Sundry Print Report

Well Name: JAMES RANCH UNIT

Type of Action: Plug and Abandonment

PLUG AND ABANDON WELLBORE
JAMES RANCH UNIT 065
EDDY COUNTY, NEW MEXICO
Class II

JRU 065 - Proposed WBD

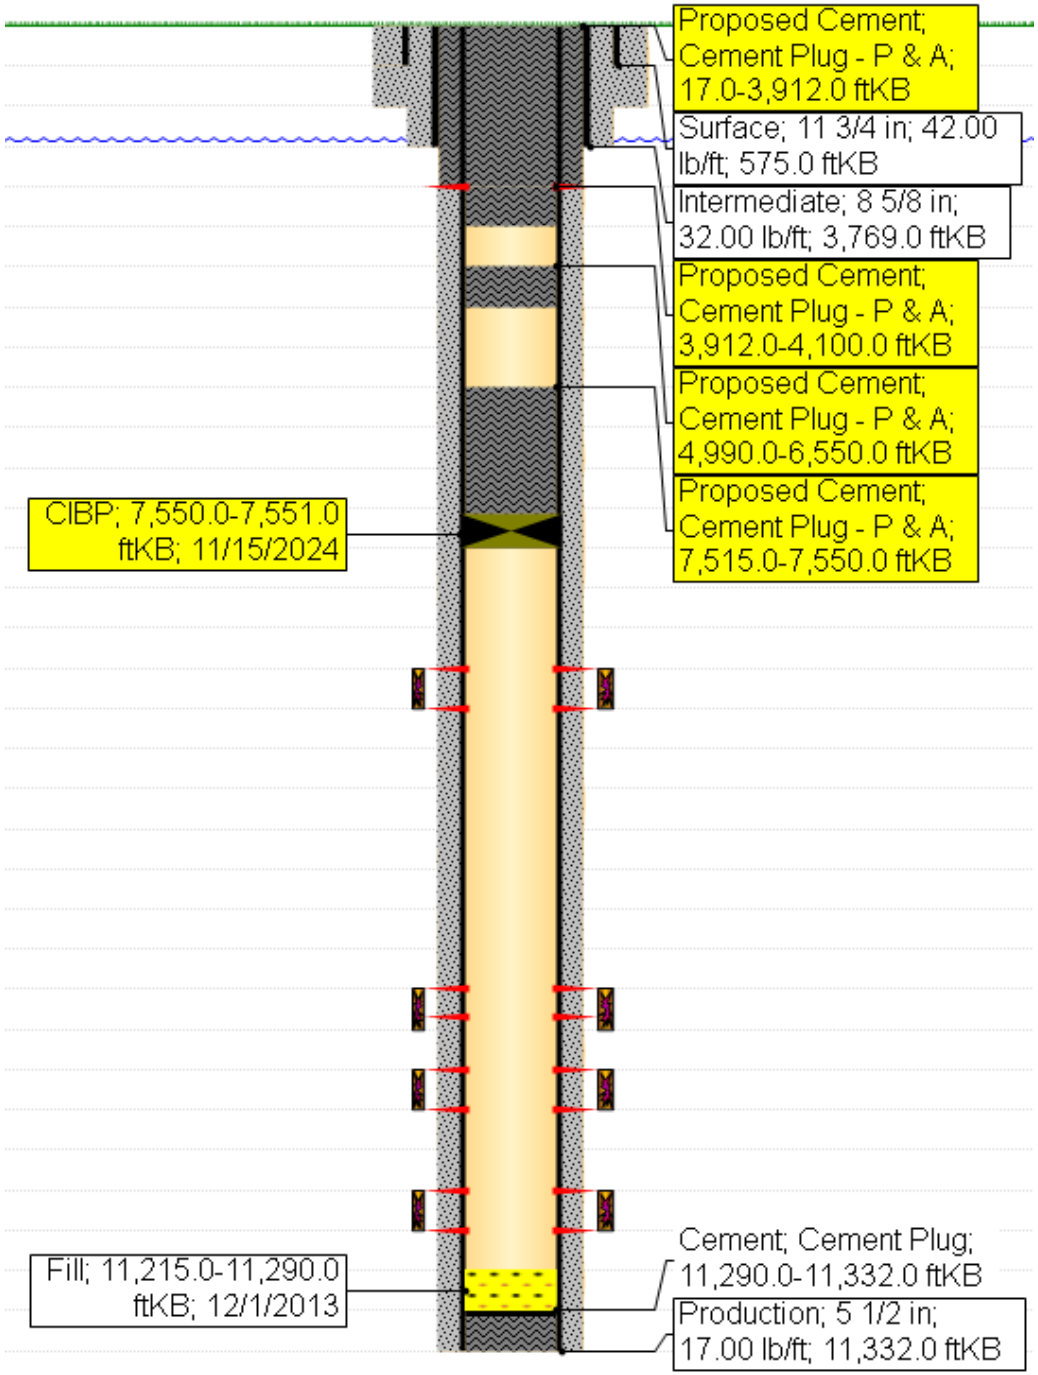
Perf and circulate from TOC to surface.

Spot 20 SKS Class C from 4,100’ to TOC. WOC and Tag.

Spot 200 SKS **Class H** from 6,550’ to 4,990’. WOC and Tag.

Dump bail 35’ Class H atop CIBP: 7,550’ to 7,515’. PT CIBP to 500 PSIG for 30 min. WOC and Tag.

JRU 065 - Proposed WBD

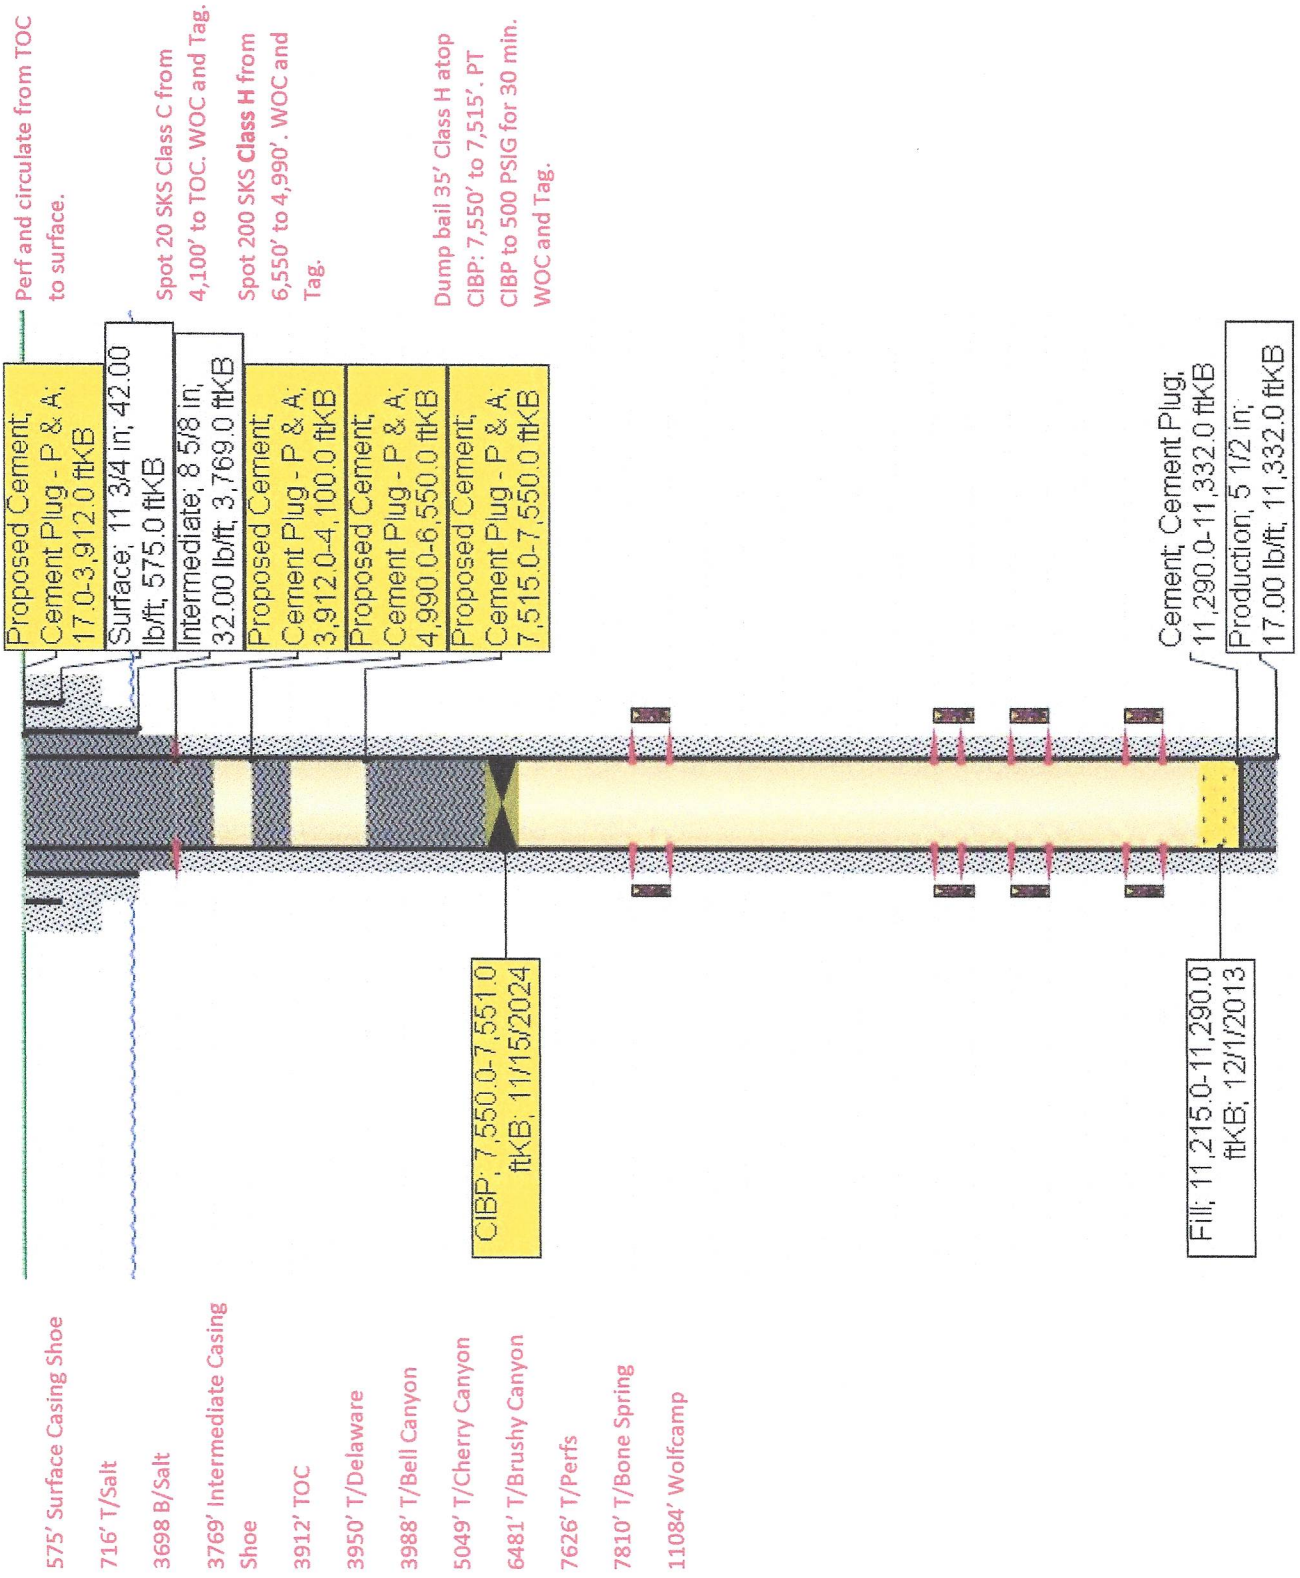
14) Circulate Class C cement from TOC to surface. (~~850~~ 912 SKS) (Intermediate Casing Shoe, B/Salt, T/Salt, Surface Casing Shoe) (In 387 sxs / Out 525 sxs)

11.75 inch- Shoe Plug	519.25	625.00	105.75	Tag/Verify			
Top of Salt @ 716	658.84	766.00	107.16	Tag/Verify			
Base of Salt @ 3698	3611.02	3748.00	136.98	Tag/Verify	912.00	C	Perf and squeeze at TOC to surface. (In 387 sxs/Out 525 sxs)

8.625 inch- Shoe Plug	3682.30	3820.00	137.70	Tag/Verify			
Delaware @ 3984	3894.16	4034.00	139.84	If solid base no need to Tag (CIBP present and/or Mechanical Integrity Test), If Perf & Sqz then Tag, Leak Test all CIBP if no Open Perforations	20.00	C	Spot cement from 4100' to 3912'. WOC and Tag.
Spacer Plug @ 6500	6385.00	6550.00	165.00	If solid base no need to Tag (CIBP present and/or Mechanical Integrity Test), If Perf & Sqz then Tag, Leak Test all CIBP if no Open Perforations	25.00	C	Spot cement from 6550' to 6385'.
Perforations Plug (If No CIBP)	7509.64	7686.00	176.36	Tag/Verify

CIBP Plug	7515.00	7550.00	35.00	If solid base no need to Tag (CIBP present and/or Mechanical Integrity Test), If Perf & Sqz then Tag, Leak Test all CIBP if no Open Perforations	4.00	C	Set CIBP at 7550' and dump bail 35' on top. Leak test CIBP.
Bonesprings @ 7780	7652.20	7830.00	177.80	If solid base no need to Tag (CIBP present and/or Mechanical Integrity Test), If Perf & Sqz then Tag, Leak Test all CIBP if no Open Perforations			
Perforations Plug (If No CIBP)	10384.60	10590.00	205.40	Tag/Verify			
Perforations Plug (If No CIBP)	10397.47	10603.00	205.53	Tag/Verify			
Perforations Plug (If No CIBP)	10893.46	11104.00	210.54	Tag/Verify			
Wolfcamp @ 11084	10923.16	11134.00	210.84	If solid			
Perforations Plug (If No CIBP)	11047.90	11260.00	212.10	Tag/Verify			
5.5 inch- Shoe Plug	11168.68	11382.00	213.32	Tag/Verify

Created By	Condition	Condition Date
gcordero	Set CIBP @ 11000' - Test CIBP - DB 35' cement - WOC & Tag	12/6/2024
gcordero	Run CBL from CIBP at 7550' to Surface	12/6/2024
gcordero	A Cement Bond Log (CBL) is required to be submitted to electronic permitting.	12/6/2024
gcordero	Submit Cement Bond Logs (CBL) prior to submittal of C-103P.	12/6/2024
